APPLICATION NO.	FILING DATE	FIRST NAMED INVENTOR	ATTORNEY DOCKET NO.	CONFIRMATION NO.
10/804,651	03/19/2004	Tae Han Jee	060944-0200	7754
24341	7590	12/07/2005	EXAMINER	
MORGAN, LEWIS & BOCKIUS, LLP. 2 PALO ALTO SQUARE 3000 EL CAMINO REAL PALO ALTO, CA 94306			BINDA, GREGORY JOHN	
			ART UNIT	PAPER NUMBER
			3679

Office Action Summary

Continuation of Attachment(s) 6). Other: Annotated sheet 1 of 10 from US 2001/0046898.

Fig. 1

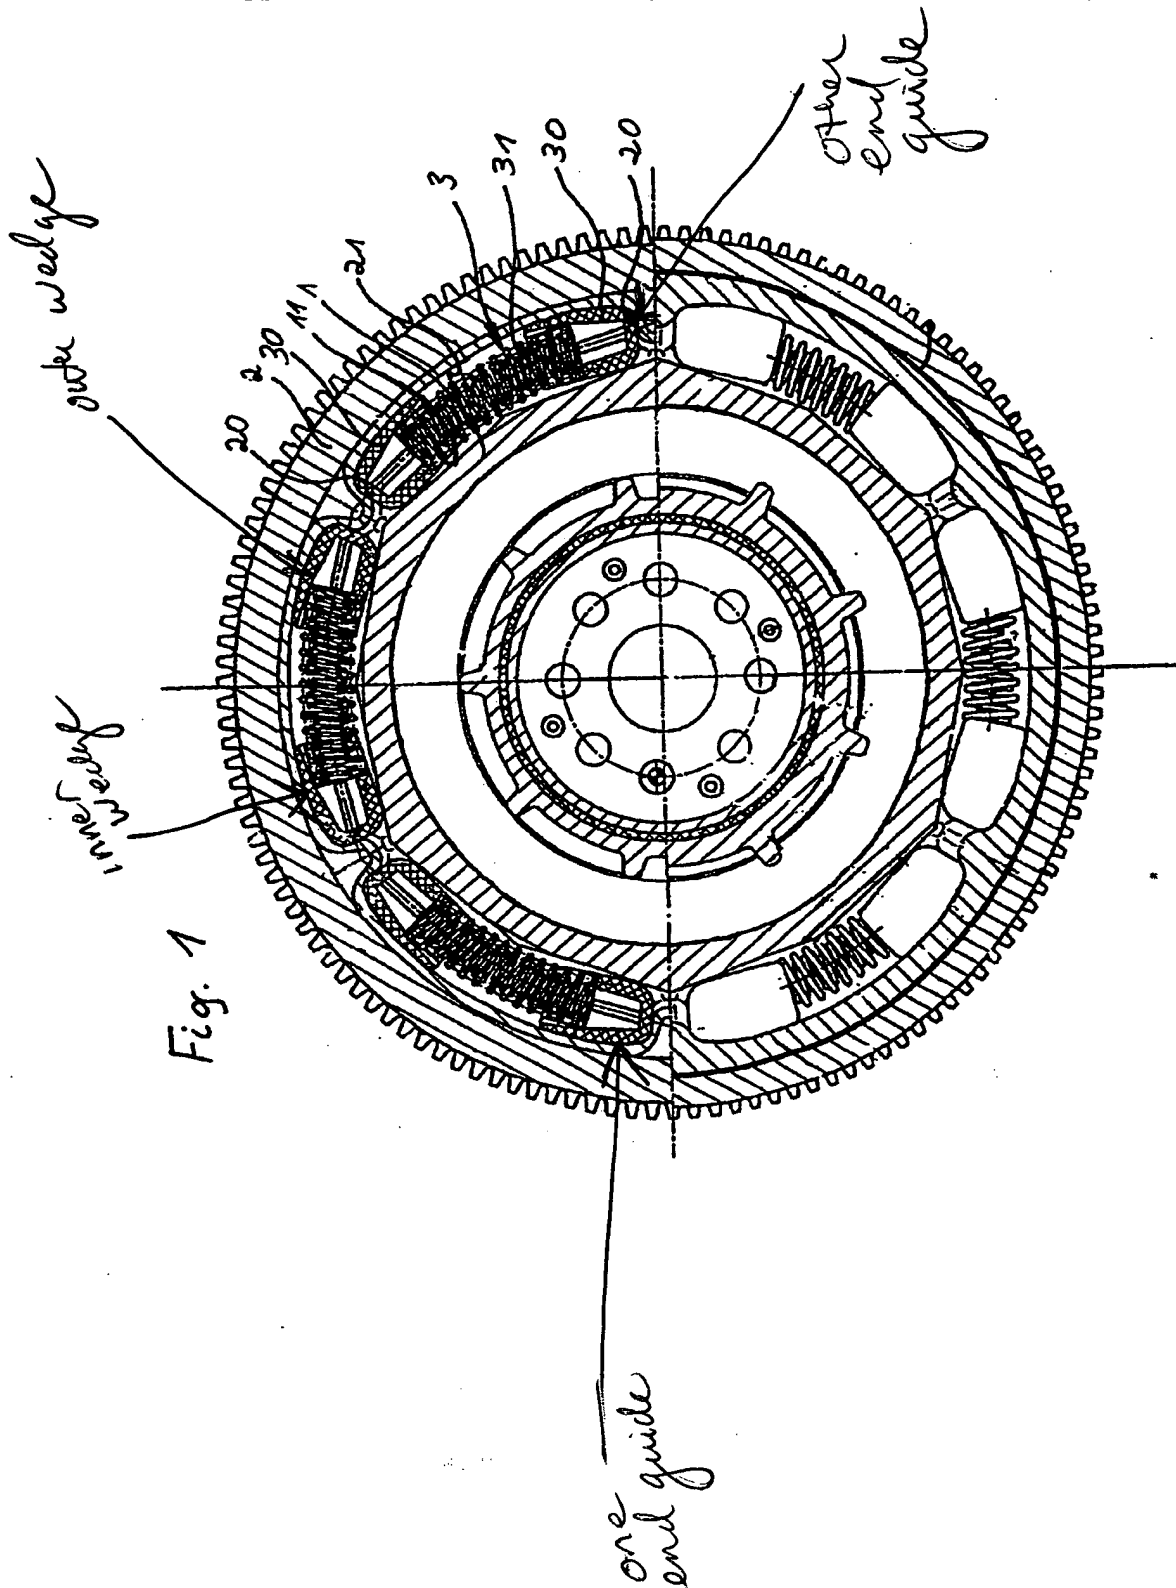
12. Claims 1, 2, 4 & 10-17 are rejected under 35 U.S.C. 102(b) as being anticipated by Rohs et al, US 2001/0046898. Fig. 1 shows a torsional vibration damper comprising: a primary mass

2 adapted to be coupled to an engine crankshaft, the primary mass defining a substantially ring-shaped chamber that is divided into at least two portions; a secondary mass 1 relatively rotatably connected to the primary mass and connectable with a clutch; and a damping unit (see the coupling elements 3) for coupling the primary and secondary masses to each other in a rotationally elastic manner. Fig. 1 show the damping unit comprises: a plurality of elastic members 31 situated in series and disposed one after the other within the divided portions of the ring-shaped chamber; a pair of end guides (see attached annotated Fig. 1) slidably disposed within each divided portion of the ring-shaped chamber and supporting outer ends of the elastic members 31; and a wedge shaped friction member slidably disposed between neighboring elastic members, the wedge-shaped friction member comprising an inner wedge and an outer wedge (see attached annotated Fig. 1). Fig. 5 shows each wedge is provide with a slanted surface 43. Figs. 7-10 show that when the slanted surfaces contact each other, the inner wedge moves inward and the outer wedge moves outward.
